STATE OF MAINE  
 DEPARTMENT OF TRANSPORTATION  
 16 STATE HOUSE STATION  
 AUGUSTA, MAINE 04333-0016

October 11, 2013  
 Subject: **Weld**  
 Federal Project No: BH-1992(400) &  
 BH-1992(500)  
 State WIN: 019924.00 & 019925.00  
**Amendment No. 1**

Make the following changes to the Bid Documents:

Figure 1.

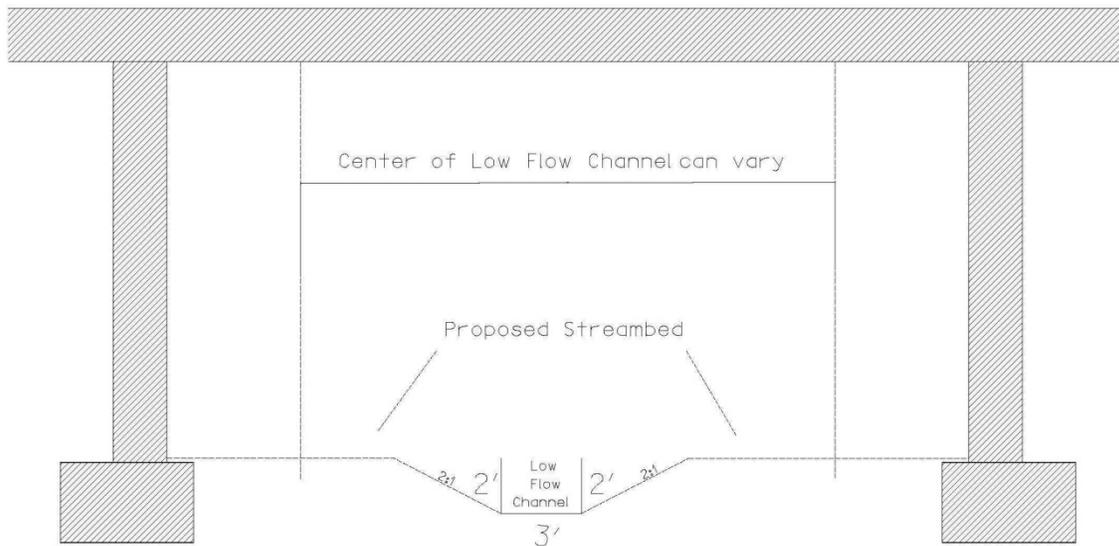
Additionally, the streambed through the bridge site shall be shaped to provide a low flow channel within the stream that will sustain fish passage in low flow conditions. The location of the low flow channel will be determined by the Resident. For a single span bridge, the low flow channel shall be three feet (2 blocks) wide and two feet lower than established streambed. There shall be a 2:1 slope from the bottom of the low flow channel to the established streambed elevation. Diagram of low flow channel configuration can be seen in Figure 1 below. For a multiple span bridge, the low flow channel only needs to be done for one span as determined by the Resident. Once the streambed/ground preparations are complete and the Contractor can demonstrate the cable mats will be installed at the desired streambed elevations (top and bottom of sag), the streambed/ground preparations shall be approved by the Resident so installation can proceed.
